Groundwater Transfer Review Summary Form

Transfer/PA # T- 14903

Ground Water Review Form:

Application: T-14903 Applicant Name: Arlene M Lucas Family Trust/Gregory G Van Damme

Map

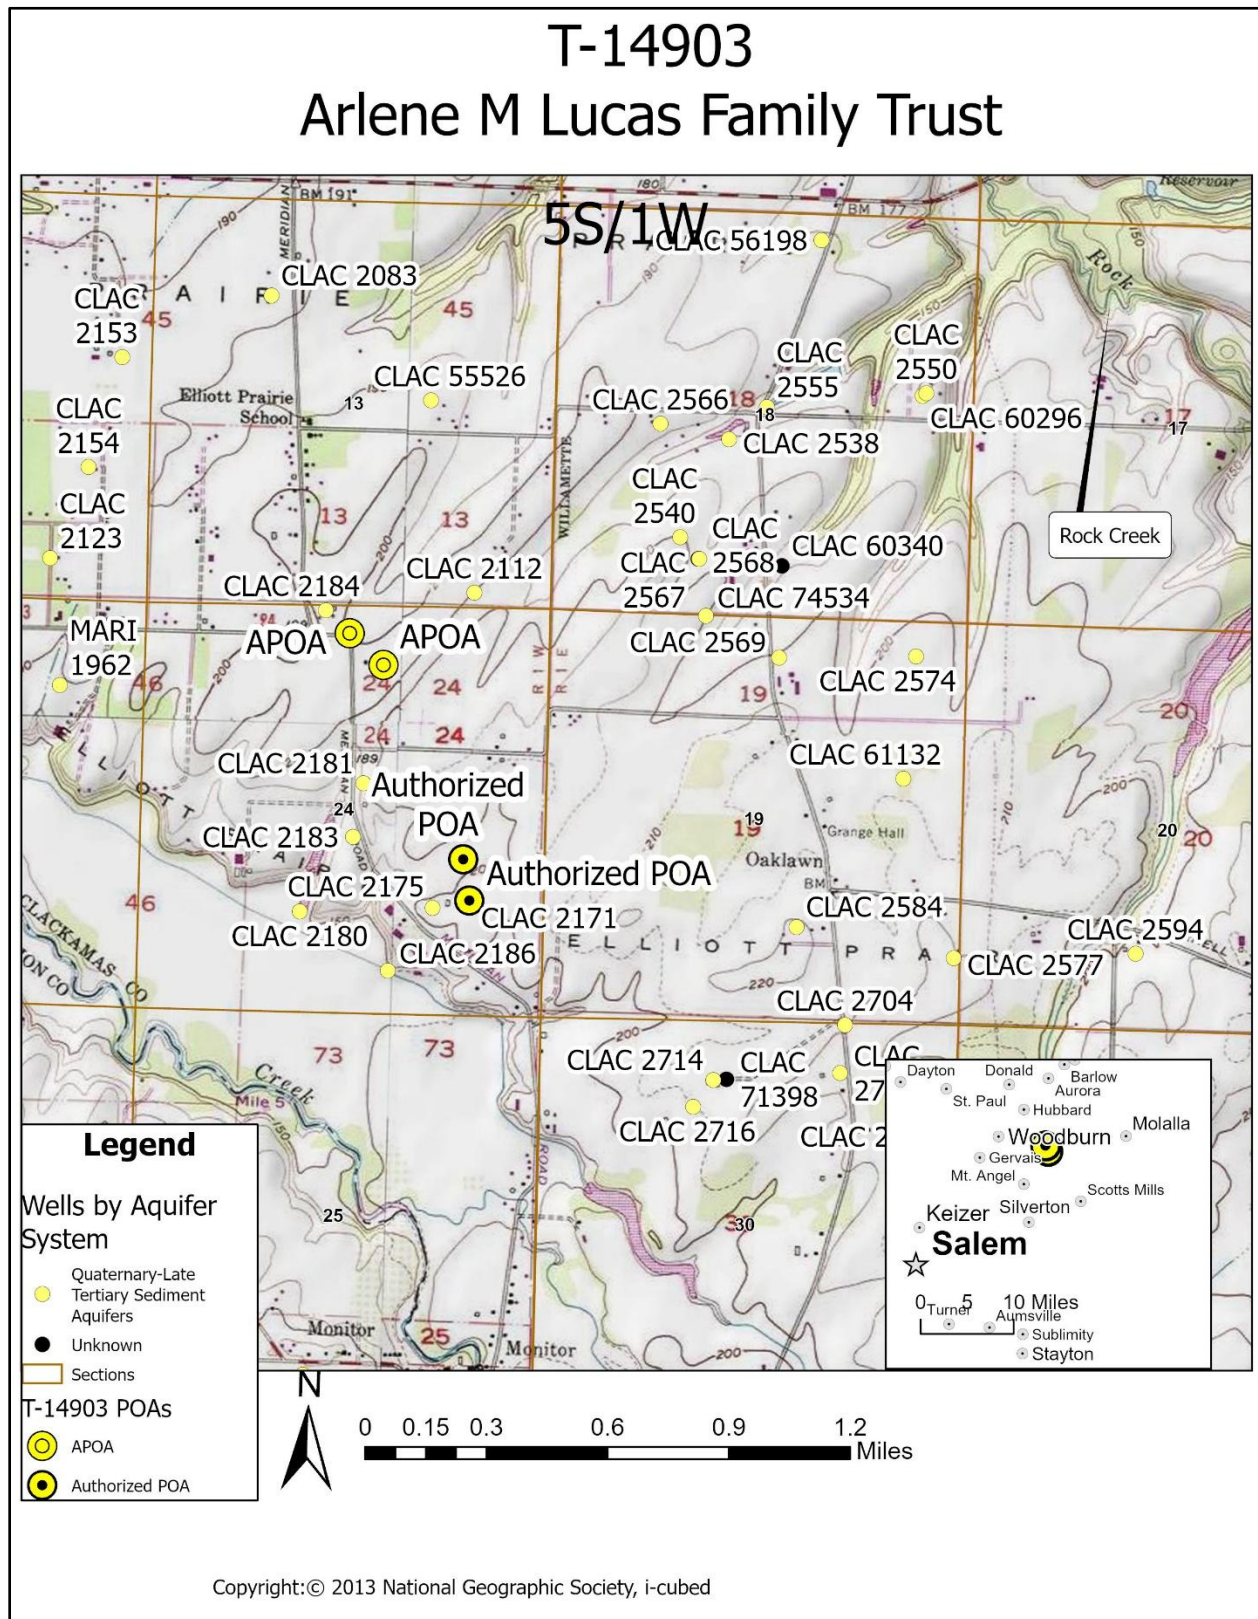
☒ Yes ☐ No Comments: APOA 3/PROP 864 is closer to CLAC 2184, which is a POA authorized under Certificate 95762. The reduced intervening distance is anticipated to result in an increase in interference with CLAC 2184.

☒ Yes ☐ No Comments: Both APOAs (PROP 863/POA-2 and PROP 864/POA-3) are closer to Rock Creek than the authorized POAs (CLAC 2173 and CLAC 2171). The reduced intervening distance is anticipated to result in an increase in interference with Rock Creek.

Provide context for minimal/significant impact: The distance between the authorized POA (CLAC 2173) to Rock Creek is approximately 11,000 ft and the distance between APOA 2/PROP 863 is 10,000 ft. Given the low transmissivity and low storativity values anticipated for this aquifer and the relatively small reduction in distance, the change in degree of interference with Rock Creek is anticipated to be minimal.

Theis Drawdown and injury analysis

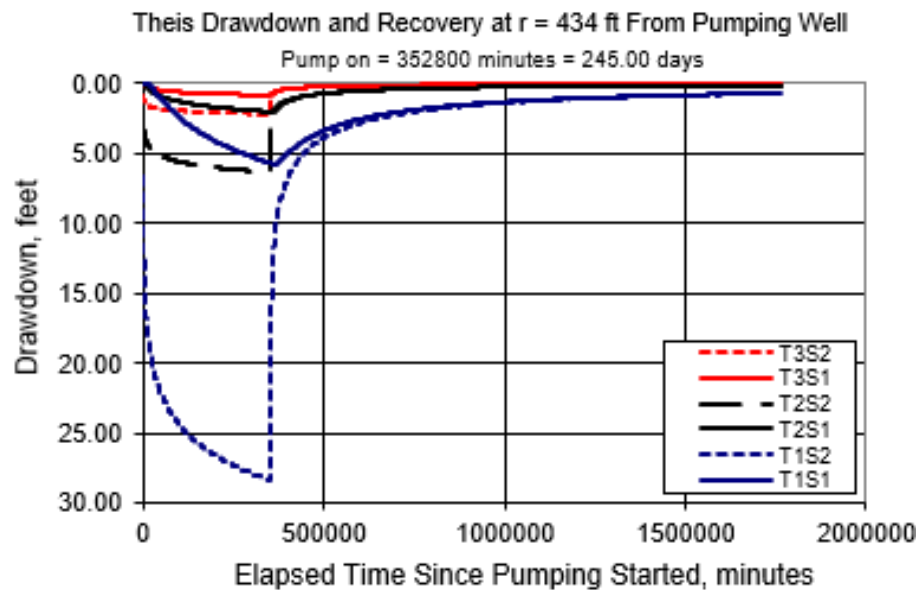
☐ Yes ☒ No If yes, explain: The Theis (1935) solution for drawdown was used to assess the potential for injury to CLAC 2184 from the proposed changes (see attached Theis Interference Analysis). Results indicate the proposed change is unlikely to result in CLAC 2184 not receiving the water to which it is legally entitled
